**City of Bellevue  
Department of Development Services  
Land Use Division Staff Report**

**Proposal Name:** Chen Short Plat  
**Proposal Address:** 4640 130<sup>th</sup> Avenue SE  
**Proposal Description:** Subdivide a 44,291 square foot lot zoned R-5 into five lots.  
**File Number:** 09-122284-LN  
**Applicant:** De-En Lang, Unique Homes LLC  
**Decisions Included:** Administrative Decision for a Preliminary Short Plat through Process II, Land Use Code 20.35.200.  
**Planner:** Mike Upston, Senior Planner  
**State Environmental Policy Act Threshold Determination:** **Determination of Non-Significance**  
**Department Decision:** **Approval with Conditions**

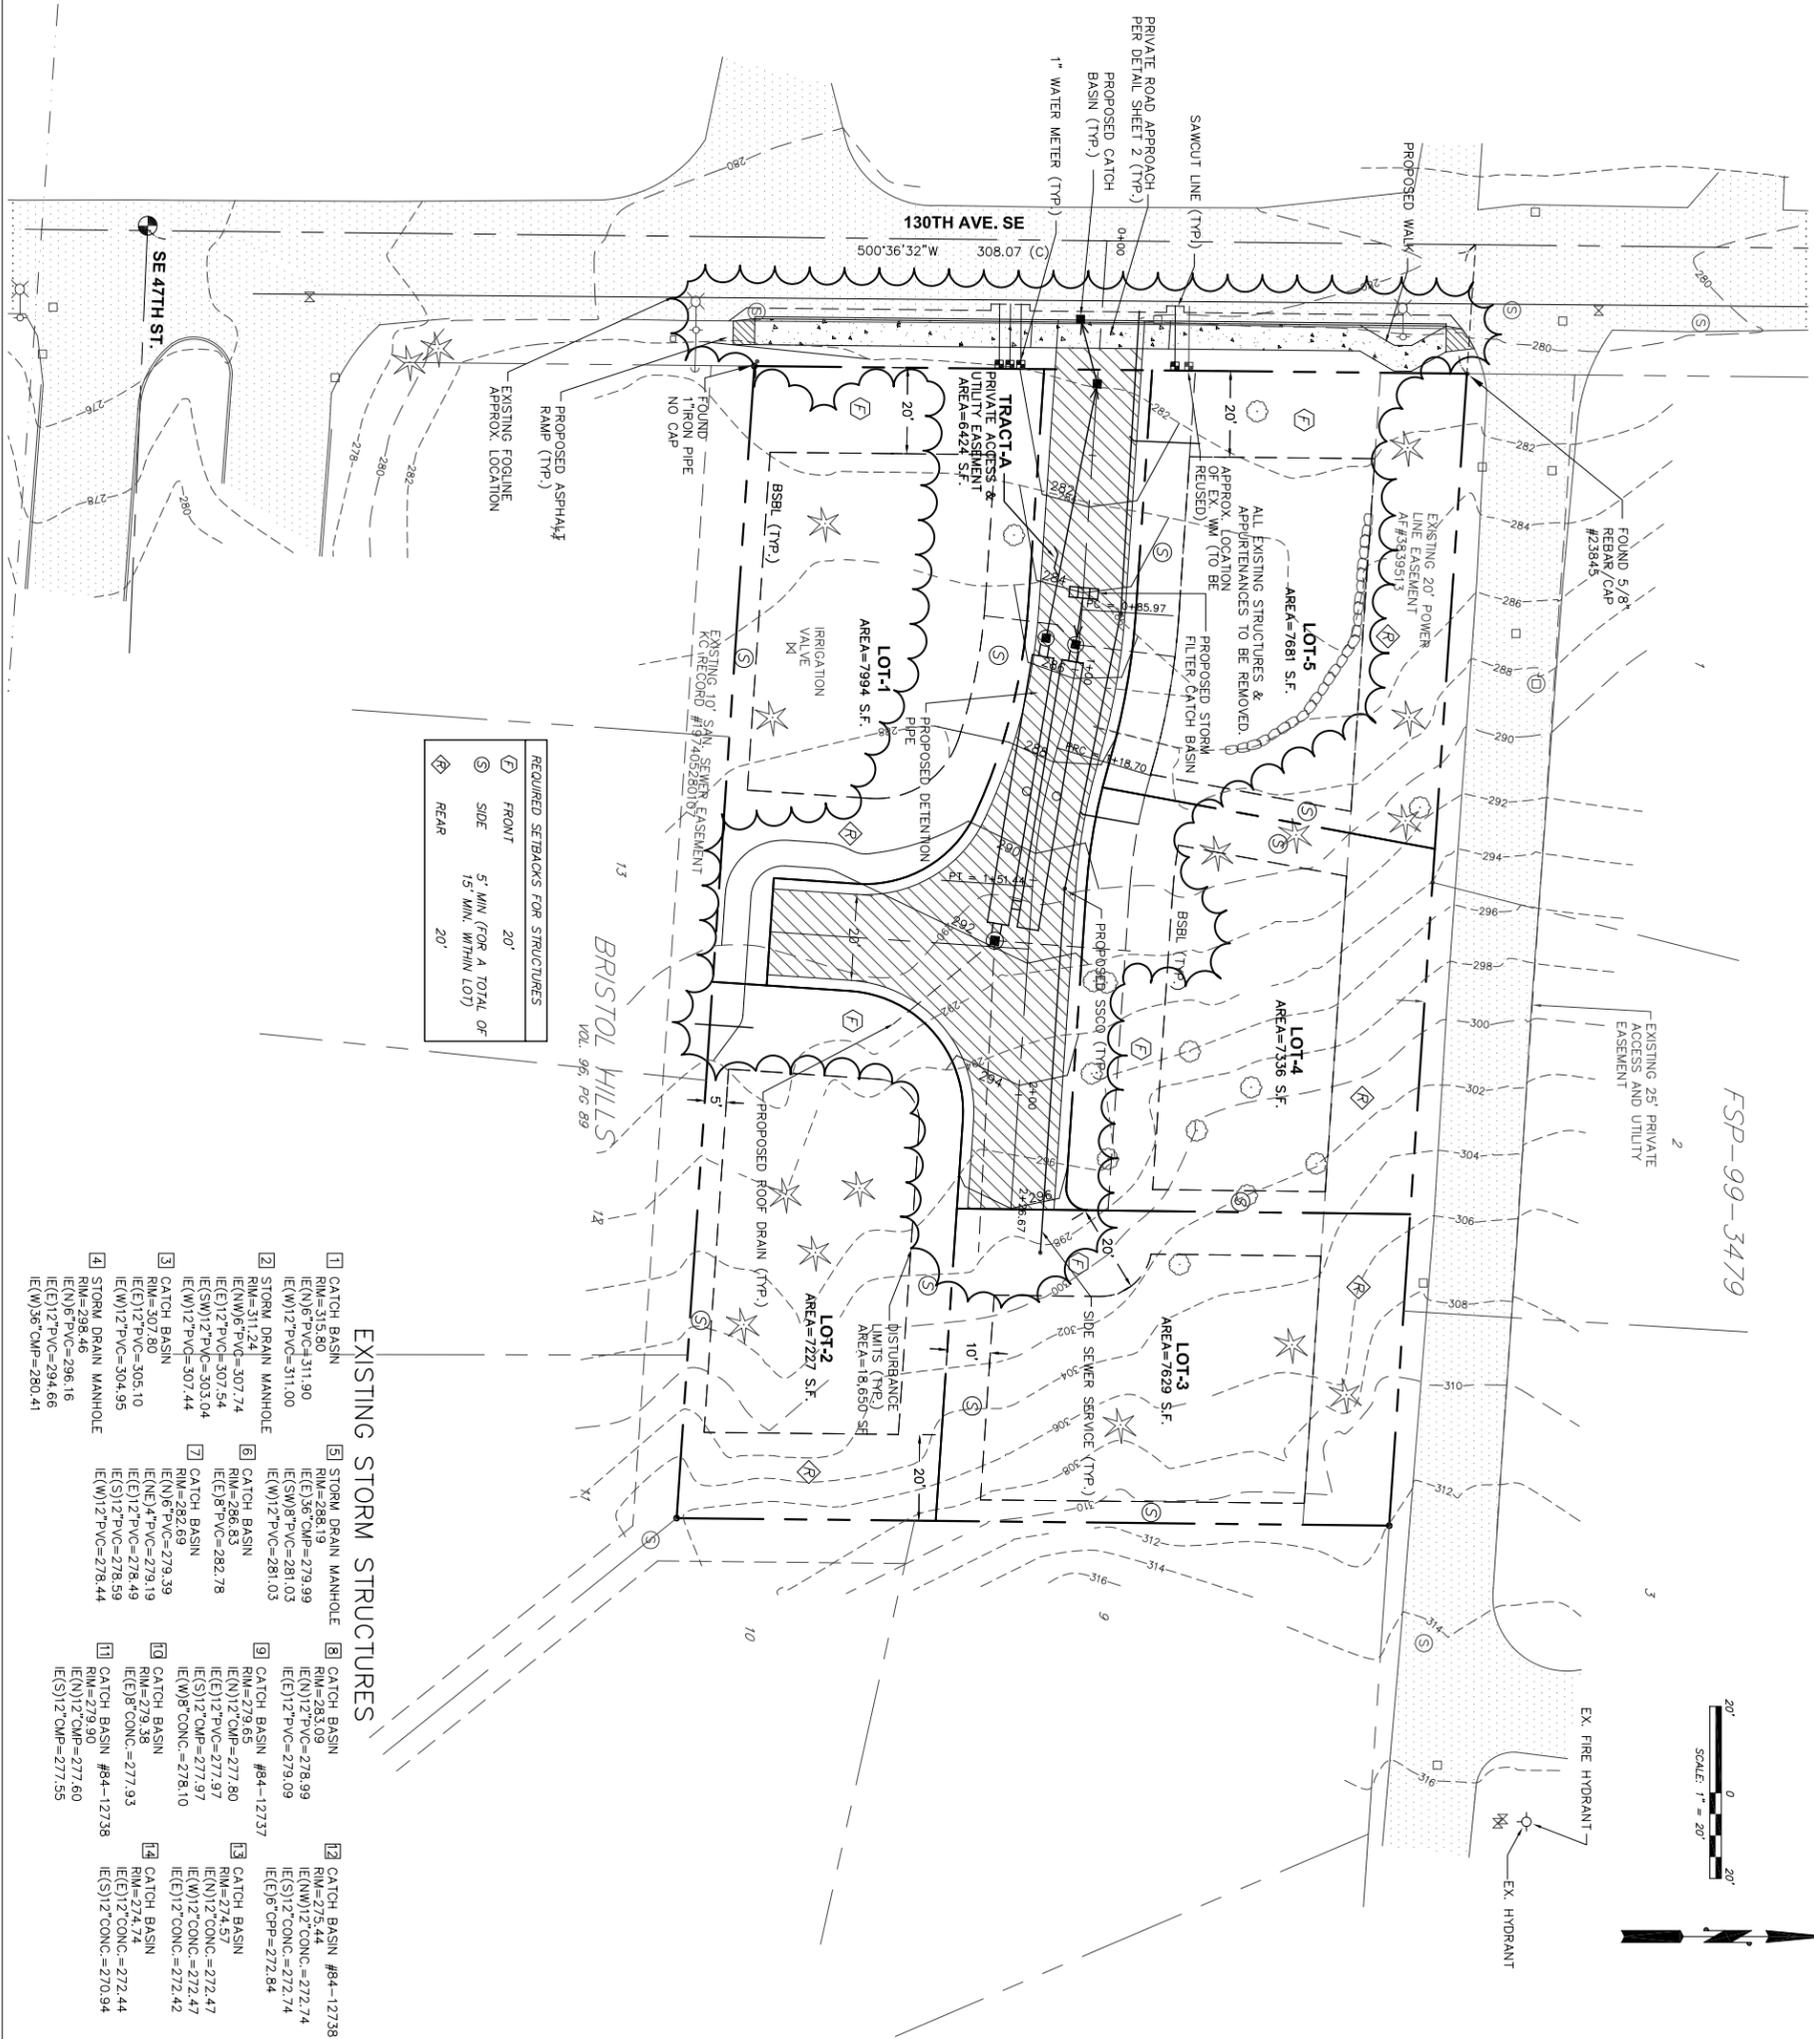
Early in review of the original PSP application, the Land Use Division requested that the required retained vegetative area (RVA) be depicted on the plan set. The final plan set now includes this information on sheet 1 of 1, Tree Retention/Slope Categories plan. This non-disturbance area is consolidated along the north property line within lots 3,4 and 5, and complies with the requirements of Land Use Code section 20.25H.110.D for Protected Area/Sensitive Earth Conditions.

During review of the original PSP, the Land Use Division had also recommended retention of Trees #7, 8, 15 & 16. According to the updated Tree Retention/Slope Categories plan submitted with this new application 09-122284-LN, the applicant was able to retain trees #3, 4, 6, 7, 8, and 12. Refer to Significant Tree calculations on this plan sheet. As also depicted on this plan, of the 388 diameter inches of existing trees inventoried on the project site, a minimum of 58 inches (15%) are required to be preserved. This application proposes preservation of 92 diameter inches.

**Finding:** The preliminary short plat considers the physical characteristic of the site, which includes a retained vegetative area that is restricted from development by the Land Use Code. This area is labeled "Proposed RVA 3,920 SF" on sheet 1 of 1, Tree Retention/Slope Categories plan.

**CLEARING, GRADING & ROAD PLAN  
CHEN PRELIMINARY SHORT PLAT  
4640 130TH AVENUE SE**

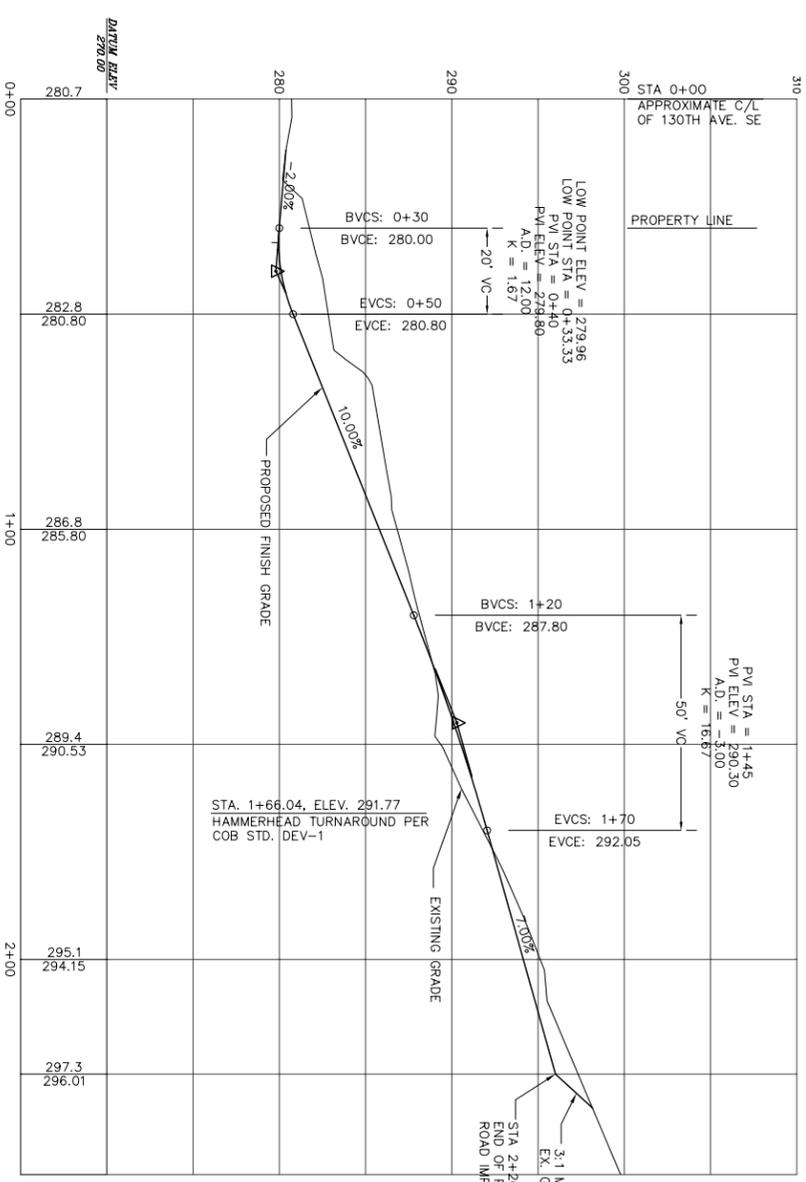
The Land Use Division had conditioned its approval of the original PSP to assure that a minimum 10 foot setback would be provided where Lots #1 and #5 face the private access road. This setback is now shown on Sheet 1 of 2, Clearing Grading & Road Plan.
